PRODUCT: 2021 15B K-Series

TITLE: Pilot adhesive change

MODELS AFFECTED: 15B-060K thru 15B-235K

NOTICE – Product Enhancement:

Photo 1: Original location of adhesive

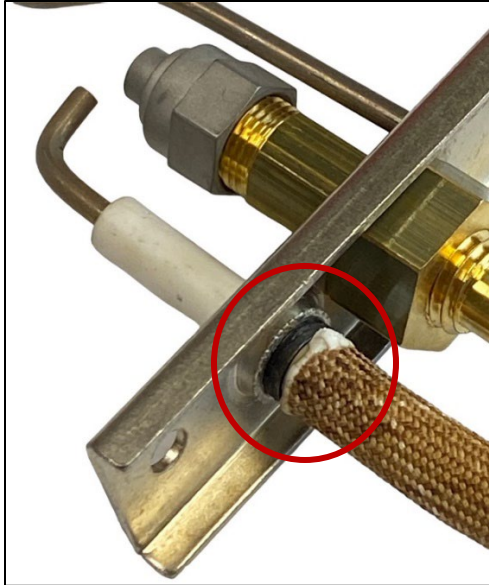
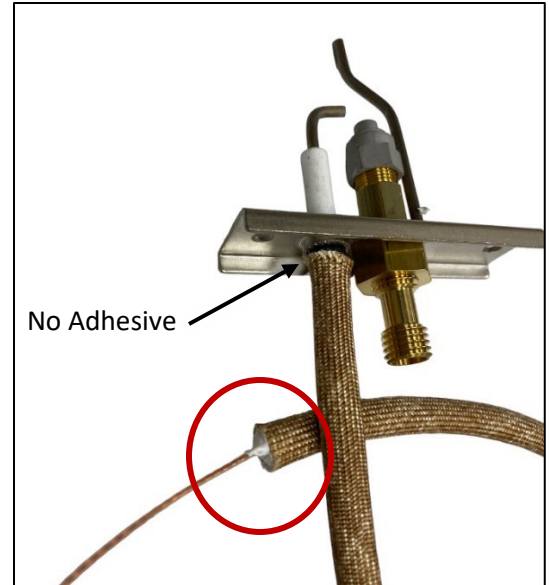
Infrequent field reports of nuisance failures associated with the 15B-K series boilers has prompted a change to the pilot assembly. The change eliminates any potential for electrical continuity created by the adhesive that holds the fiberglass sleeve in place. Electrical continuity in the area of the pilot ignitor can interfere with the flame rectification circuit and cause a nuisance shutdown.

The primary symptom is the pilot lights but the main burners are not activated. You may also notice in some cases that the ignitor continues to spark after the pilot is lit. For boilers utilizing the Resideo (Honeywell) S9361A control, the control may display an error E-57 or an erroneous error code.

To prevent any possible electrical continuity between the ignitor and ground the adhesive used to hold the fiberglass sleeve in place has been moved from the ignitor to the other end of the sleeve. This was a rolling change implemented in March of 2023. See photos 1 & 2.

1. Temporary fix: Roll back the fiberglass sleeve and remove the adhesive. The adhesive can be removed by scraping it away. Use a wire tie at the opposite end of the fiberglass sleeve to hold it in place so that the pilot end covers the igniter.

2. Permanent Fix: Replace the pilot assembly, kit no. 550003793. Ensure the new pilot does not have adhesive on the igniter end of the fiberglass sleeve.
